DEPARTMENT OF COMMUNITY DEVELOPMENT SERVICES

TO: The Urbana Zoning Board of Appeals

DATE: November 9, 2006

SUBJECT: **ZBA Case # 2006-A-01:** an Appeal of an Interpretation of the Urbana Zoning Ordinance made by the Urbana Zoning Administrator disallowing an off -street parking area located within the required 15-foot front yard setback at 805 W. California Avenue in the R-4, Medium Density Multiple Family Residential Zoning District.

Site Diagram - 805 W. California

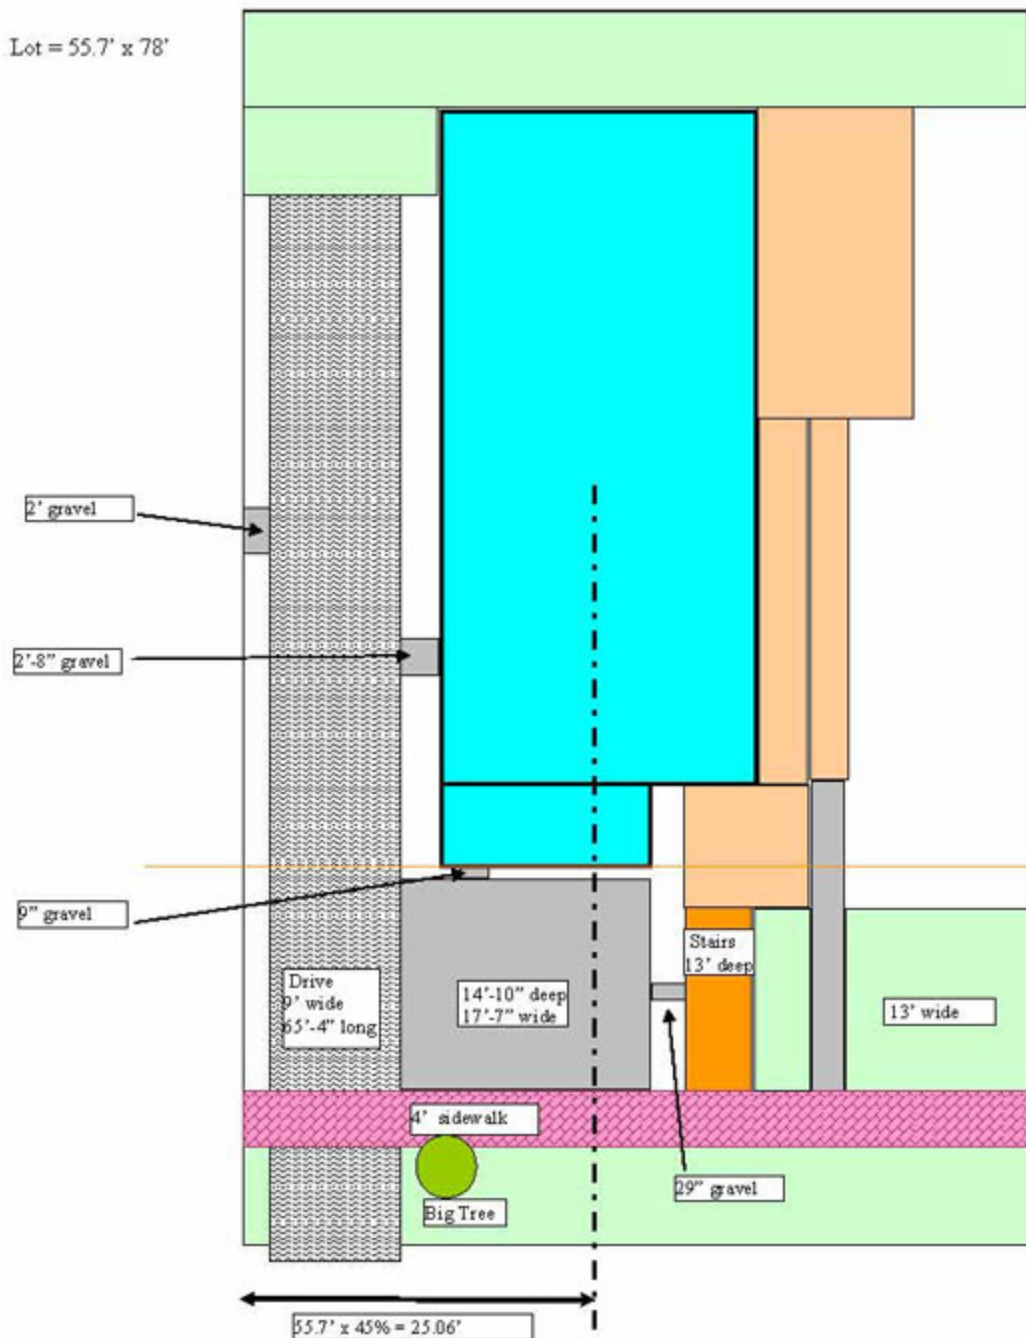
The Zoning Administrator interprets Section VIII-4.F.1 such that compliance with the 45% limitation does not remove the primary regulatory import of this section that said parking be contained within the access drive. Furthermore, even if the Zoning Administrator were to allow the use of the parking area, the measured dimension does slightly exceed the 45% limit, as

shown on the attached exhibit. The combined width of the access drive and car pad is 26 feet, 7 inches wide. This is 48% of the 55.7-foot width of the lot.

Should the Zoning Board overturn the Zoning Administrator's decision, modification to the parking area or granting of a variance would be necessary to ensure compliance with the 45% restriction on the combined width of the access drive and parking area.
